Amendments to the Drawings

Remarks/Arguments

FIG. 6

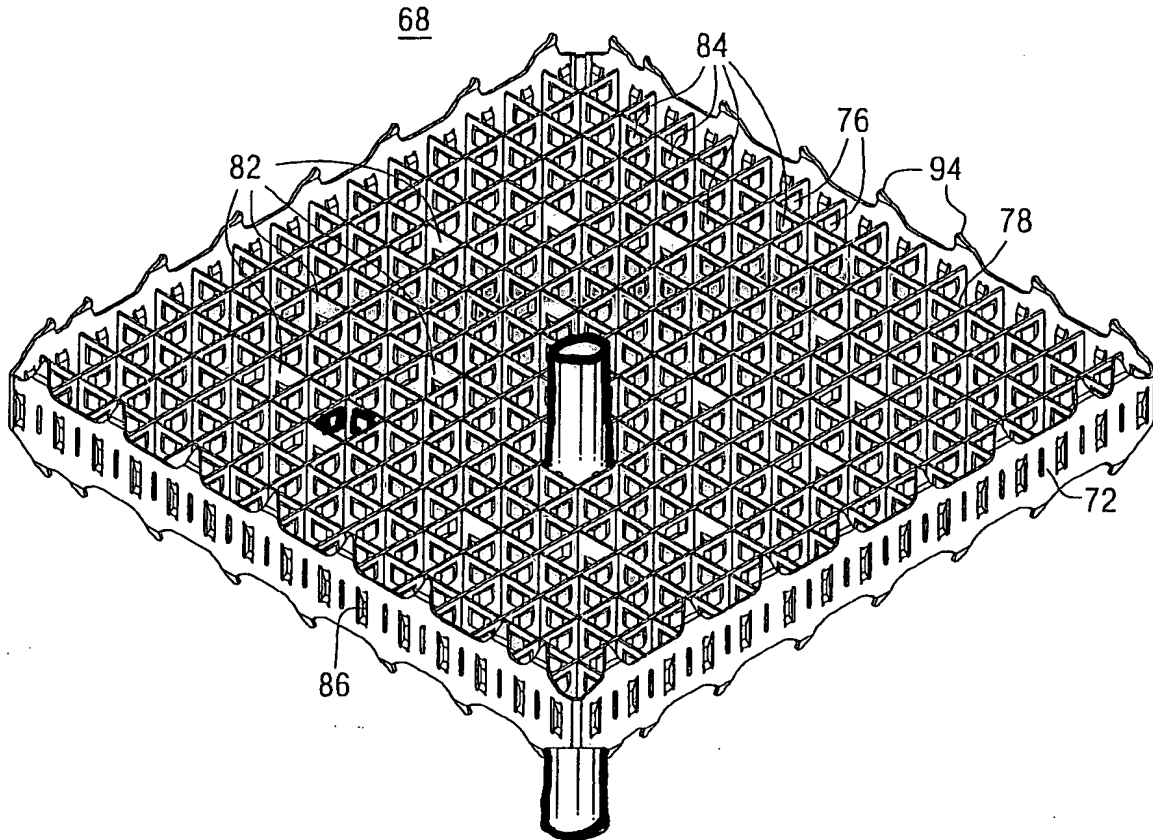
The attached sheet of drawings include changes to Figure 6. This sheet, which includes Figure 6, replaces the original sheet and any previous amendments including Figure 6. In Figure 6, the control rod guide tube and the welds that attached the control rod guide tube to the grid cell have been removed. Figure 6 has also been amended to better show that the springs in the grid cells that have springs, i.e., fuel rod support cells, are coplanar and are oriented in the vertical direction. Support for this clarification can be found on page 11, starting on line 5 and on page 11 starting on line 8.

Applicants' attorney respectfully disagrees with the Examiner's position. However, for the sake of advancing prosecution, applicants have further amended Figure 6 to clearly show that the dimples and/or springs are on the vertical and they are all within the same plane. Addressing the relative dimensions, the Examiner's attention is directed to Figure 5, which clearly shows the springs on a diagonal with the contact area shown relative to the width of the cell as being substantially less than that shown for the vertical springs and dimples shown in Figure 6 relative to the cell wall width illustrated in Figure 6. The Federal Circuit in *Hockerson-Halberstadt Inc. v. Avia Group International, Inc.* (222 F.3d 951,956, and 55 USPQ F.2d 1487,1491 Fed. Cir. 2000) stated: "It is well established that patent drawings do not define the precise proportions of the elements and may not be relied on to show particular sizes if the specification is completely silent on the issue." Thus, the court is acknowledging that the patent drawings do not have to show the precise proportions. Here, however, the specification does add to the drawings by clearly stating on page 11, starting at line 6, that the dimples and/or springs are co-planar, and on line 8, that the springs are on the vertical rather than on the diagonal. Starting at line 29, the specification specifically states: "The inner straps 76 and 78 on the auxiliary grids provide for a larger contact area between the dimple/springs and the fuel elements than are provided by the corresponding contact areas on the main support grids 46. The Court of Customs and Patent Appeals stated in *In re: Chitayat*, 408 F.2d 475, 161 USPQ 224 (CCPA 1969) that: Arguments based on mere measurement of patent drawings are of little value in absence of description in specification

In a telephone interview with the Examiner on April 27, Applicants' further agreed to amend Figure 6 to remove the control rod guide thimble and welds and delete Claim 13. With those changes the Examiner agreed that the changes to the drawings would be acceptable.

The Examiner asserted that the amendment filed 9/24/04 is objected to under 35 USC § 132 because it introduces new matter into the disclosure. The Examiner asserted that Figure 6 shows a 15 X 15 array, not a 17 X 17 array. Applicants fully agree. The earlier amendment was a typographical error. Figure 6 shows the 15 X 15 array and Figure 4 shows the 17 X 17 array. This further amendment has been made to the specification to correct this error.
